700, 750, & 800 Massachusetts Avenue
- Review of July 24 submittals

Date of Issuance: 27 July 2020
To: Mr. Shawn Knuckolls, Toll Bros., Inc.
Project: 700, 750 & 800 Massachusetts Avenue - *The Enclave at Boxborough*
Subject: Design Review Board Application dated 9 July 2020 – Supplemental Documentation for the Community Clubhouse Building

To: Town of Boxborough – Design Review Board (DRB)
Project: 700, 750, & 800 Massachusetts Avenue – The Encave at Boxborough
Subject: Response to DRB Memo dated July 27, 2020 regarding application dated July 9, 2020 for Community Clubhouse Building

HANDICAP PARKING SPACE DETAIL

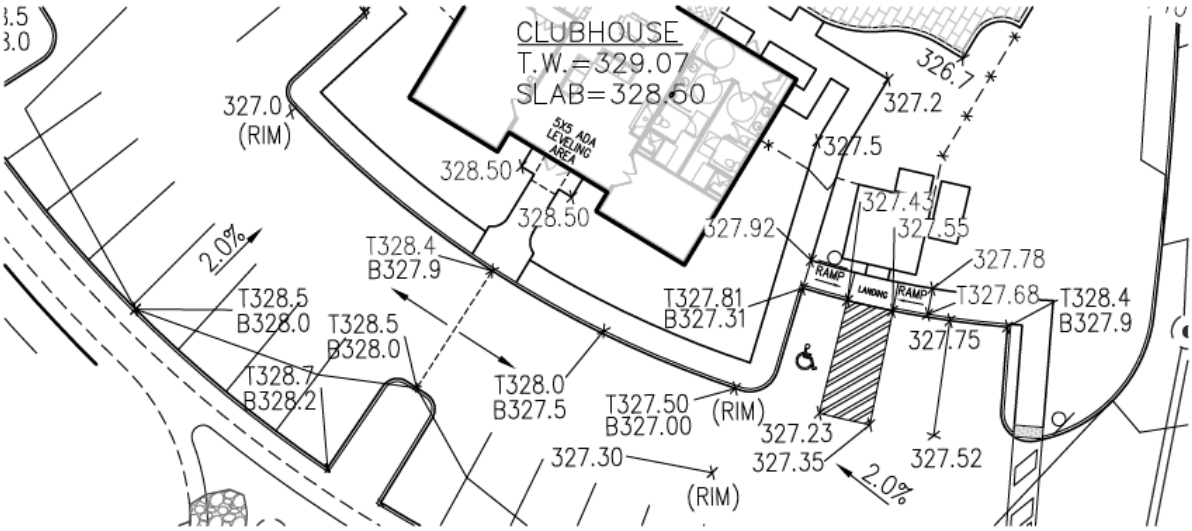
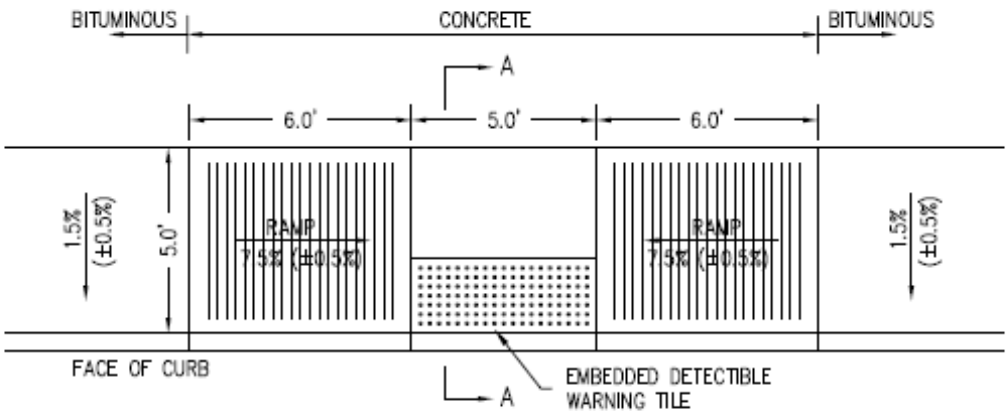
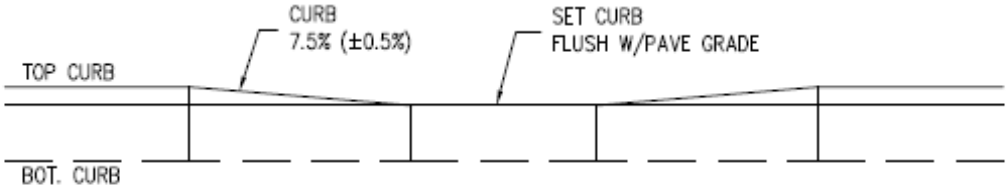
The Board has requested that the Applicant reflect an ADA compliant handicap ramp accessible to the side walk leading to the Clubhouse, Mailboxes and other Community Amenities from the handicap parking spot in the Clubhouse parking area.

6. Handicap Accessibility – reflect an ADA compliant handicap ramp accessible to the side walk from the handicap spot in parking area
    a. An updated Plan Set has been prepared by Ducharme & Dillis showing the details of this area and required accessibility. Detail Attached from plan sheet C8.5

CLUBHOUSE LIGHTING PLAN
SCALE: 1"=10'

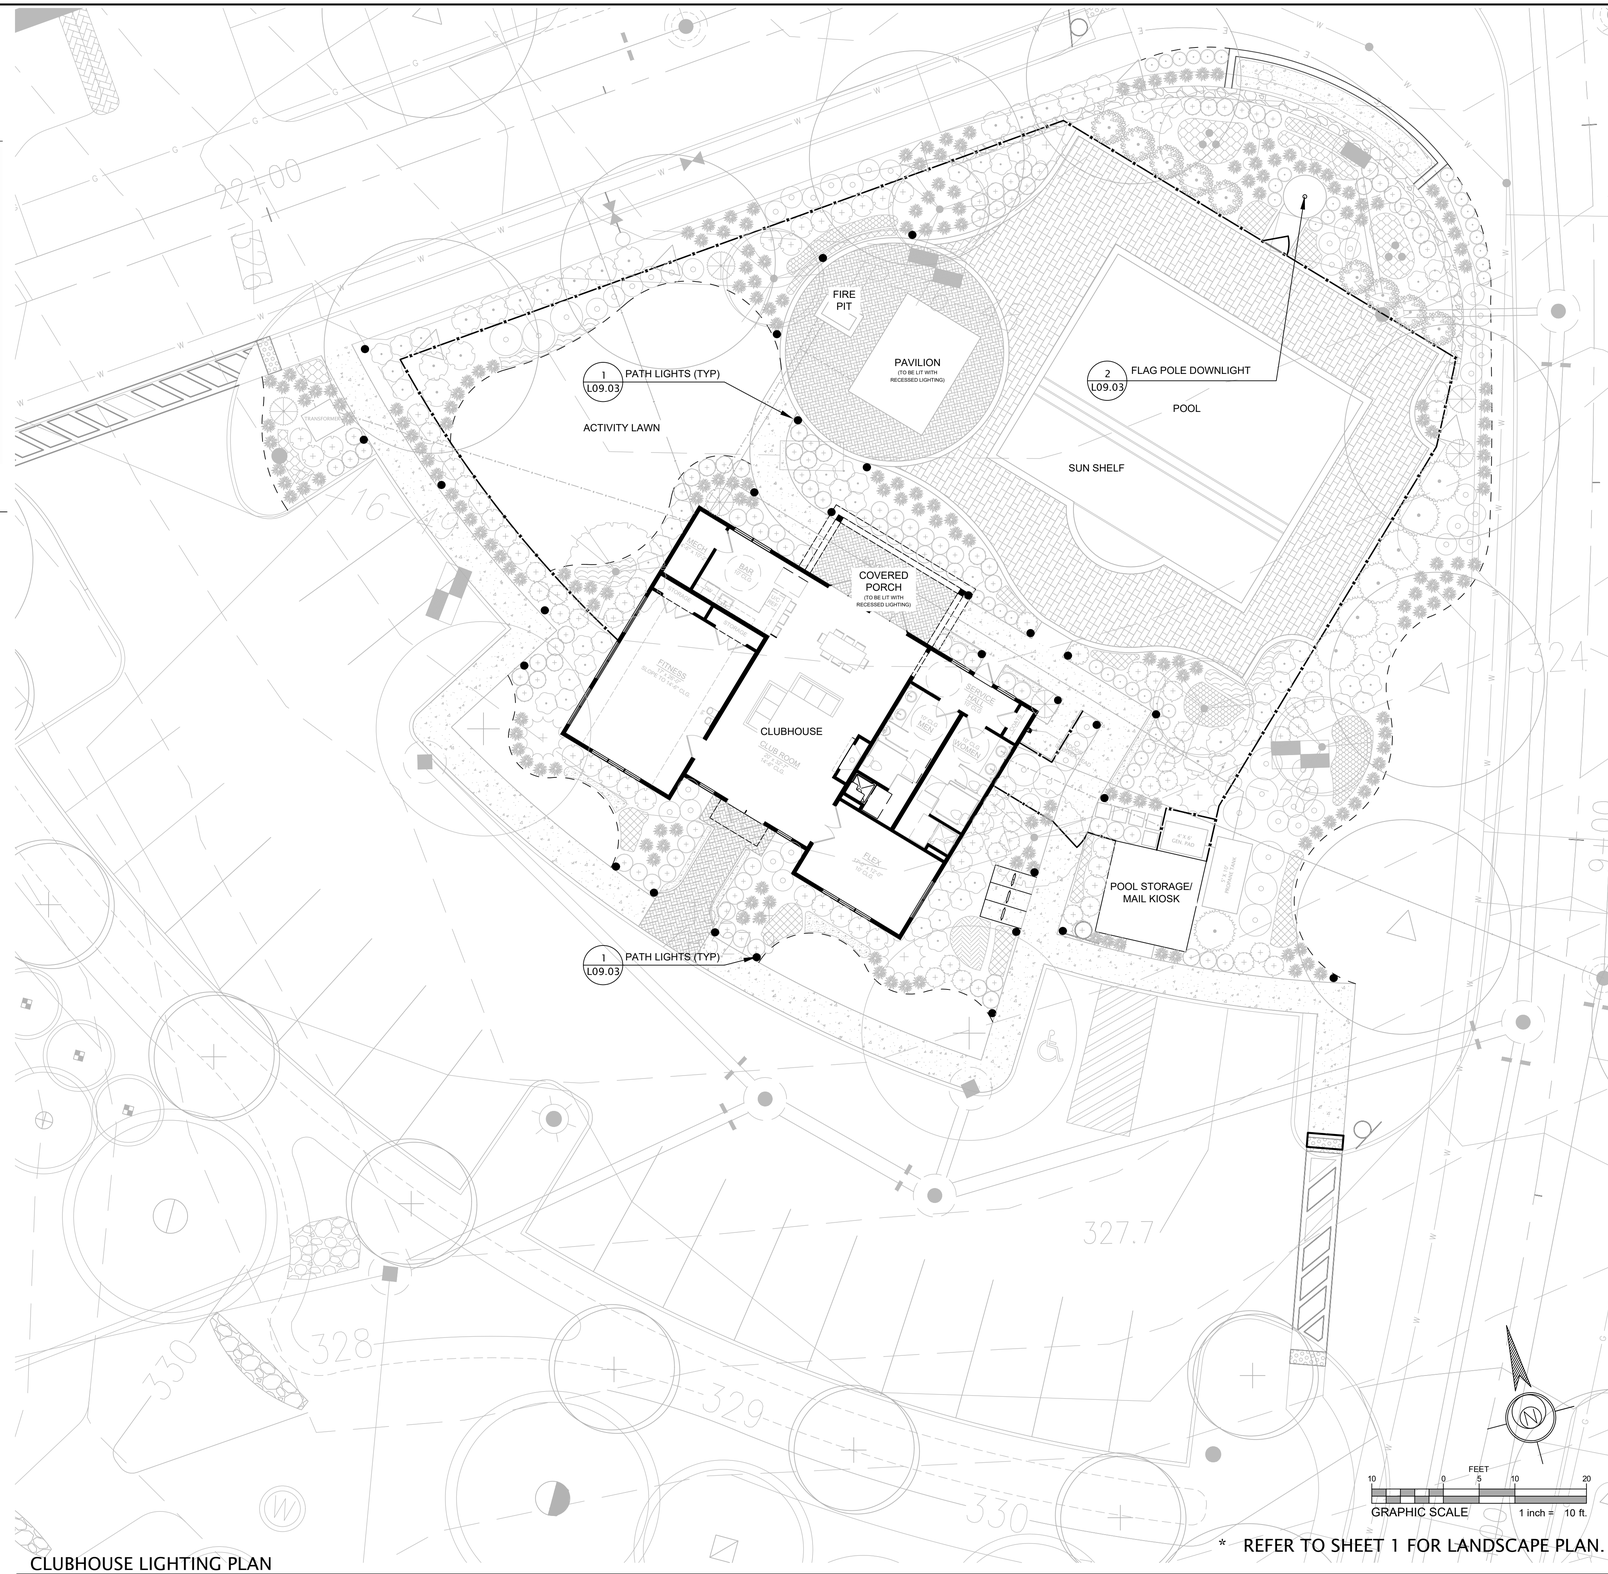
The Board has requested that the Applicant provide lighting specifications reflecting “Dark Sky” compliance.

The Board has requested that the Applicant correct the mislabeled uplights and path lights as they both shared the same graphic symbol in plan.

The Board has requested that the Applicant reflect architectural lighting for the outdoor pavilion on the pool terrace in plan.

a. Landscape lighting sheet L09.03 has been updated to confirm "dark sky" compliance. All proposed uplighting has been eliminated.
4. Lighting – correct mislabeled uplights and path lights

a. Landscape lighting sheet L09.03 has been updated to correct labels
5. Lighting – reflect architectural lighting for the outdoor pavilion
    a. Landscape lighting sheet L09.03 has added notes reflecting the inclusion of recessed lighting in both the Pavilion and Covered Porch

FRONT ELEVATION

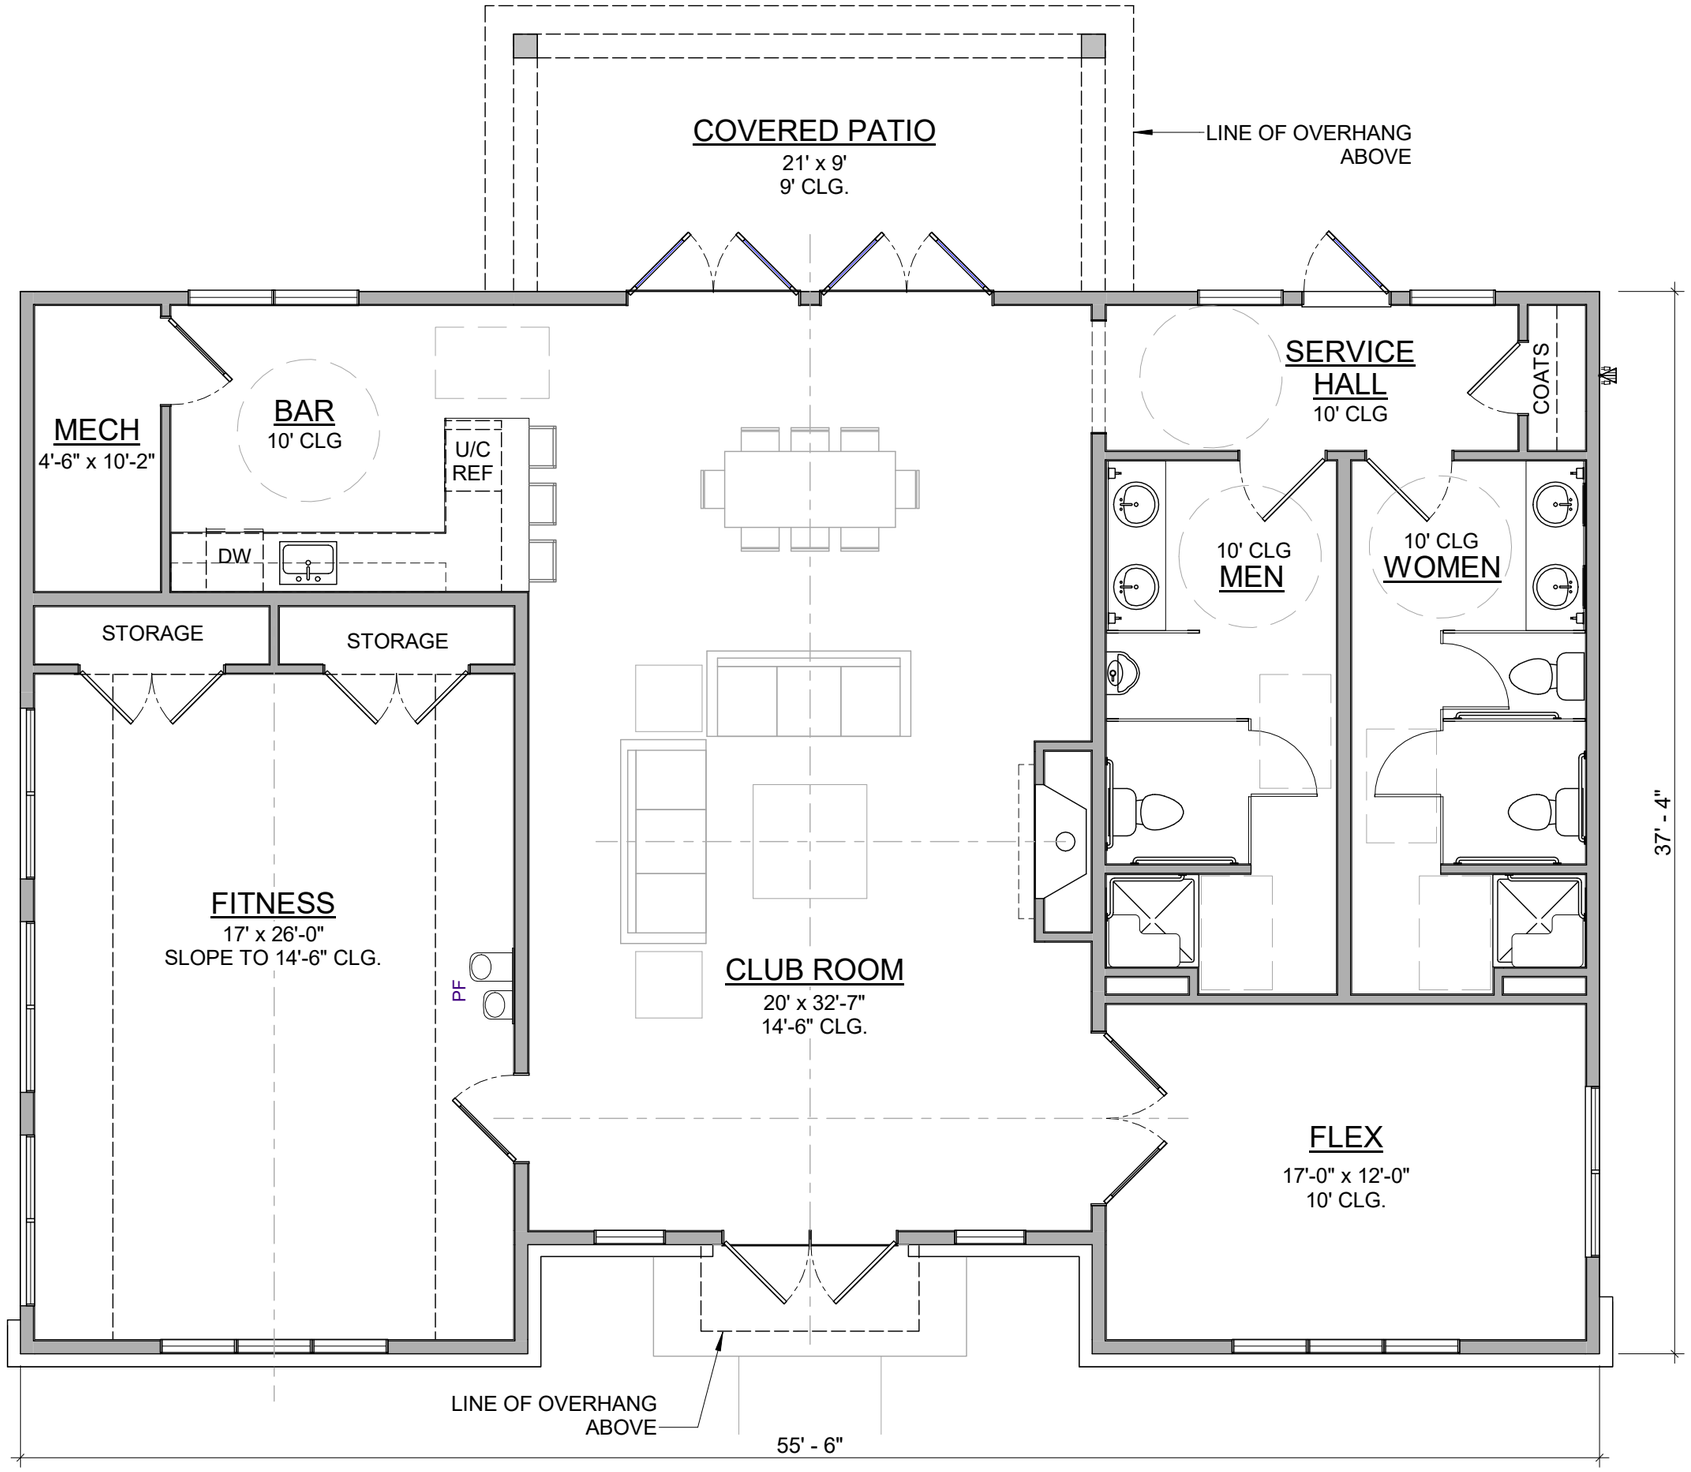
The Board has requested updated architecturals eliminating the varying roof angles above the upper dormer windows in the middle roof composition. The Board has requested a simple, consistent roof edge.

The Board has requested updated architecturals reducing the overall height of the center roof line by +/- 2'. Roof angles should be more closely in harmony with each other on the Clubhouse.

1. Front Elevation – eliminate varying roof angles over middle windows
    a. These have been eliminated from Clubhouse Plans
2. Front & Rear Elevation – reduce height of the center roof line

a. The center roof pitch has been reduced lowering this roof by 1'-6"
3. Lighting – provide lighting specifications reflecting "dark sky" compliance
